Adamstown Block G

Response to RFI

RFI Response

Landscape Architecture

Area A - Highlighted purple above

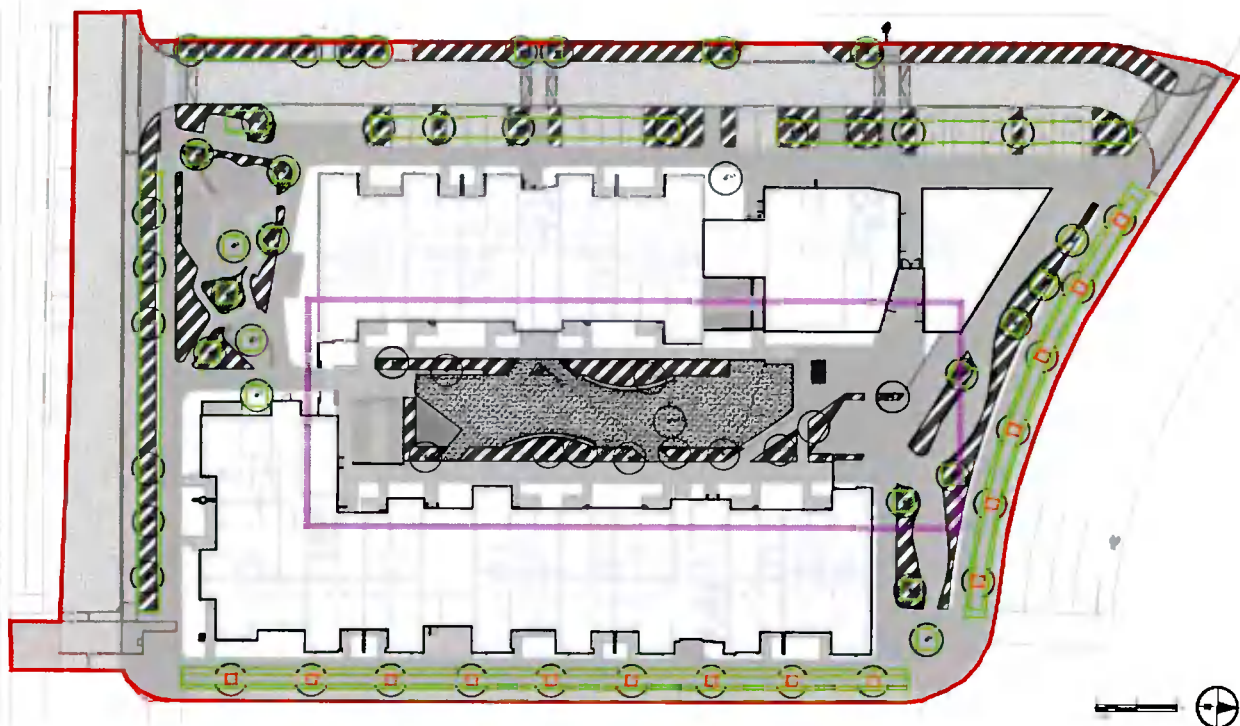
'The most northerly located bicycle parking structure (measuring approximately 79.95sq.m) is considered to be substantial and will dominate the northern end of the open/communal space. An alternative location should be sought for this bicycle storage. The applicant should investigate the incorporation of all bicycle storage within the building blocks/built fabric (similar to waste storage) and possibly omit an apartment to accommodate bicycle parking. If this is not possible, the applicant is requested to provide a sustainably 'greened' structure incorporating natural planting and green solutions within the design.'

The courtyard has been validated to provide a more integrated multi-functional space following the realignment of the cycle shelter. This has been achieved through repositioning of the cycle shelter to the north and the direct link east west to a new arrival / amenity space to the north which is now the principal point of arrival to the space. This has allowed some of the seating spaces previous located in the soft areas to be included in the design of the amenity space and given rise to a playful landscape. To achieve the playful landscape and integrate play into the overall courtyard we have looked to reorganise the footpaths to the edge of the space with a planting buffer to the edge, this has created the framework for a central lawn to be established with natural play elements integrated along the periphery of the lawn and shrub areas. Please see sheet ADB3-ACM-00-ZZ-DR-LA-1001 for the layout of the central courtyard space in response to RFI.

Area B - Highlighted purple above

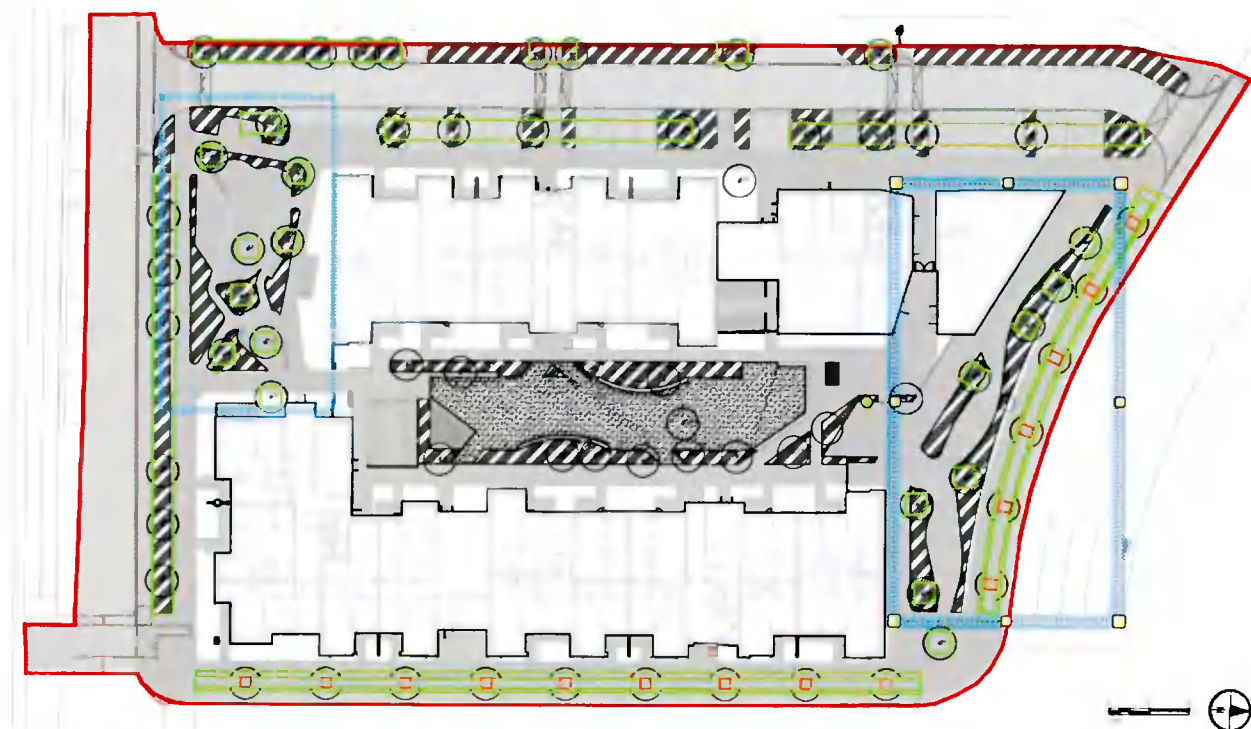
Area B - Previous planning application design

The layout and arrangement of pocket park (South) and play trail (North) is consistent with the permitted layout. The team has only aimed to the geometry of the hardscape/softscape edges to a consistent 2m radius for constructability reasons and included safety surfacing to the critical fall height areas. We want to retain the intent that these playful spaces are integrated into the surrounding context. The rationalisation of the kerb edges and geometry will give a better solution for future constructability and maintenance of the spaces highlighted above. In a similar approach to the

communal courtyard, we wanted to promote a playful landscape. It is intended that these spaces can function for rest, congregation as well as play promoting a multifunctional use within the public realm. Please see sheet ADB3-ACM-00-ZZ-DR-LA-1001 for the layout of the spaces above.
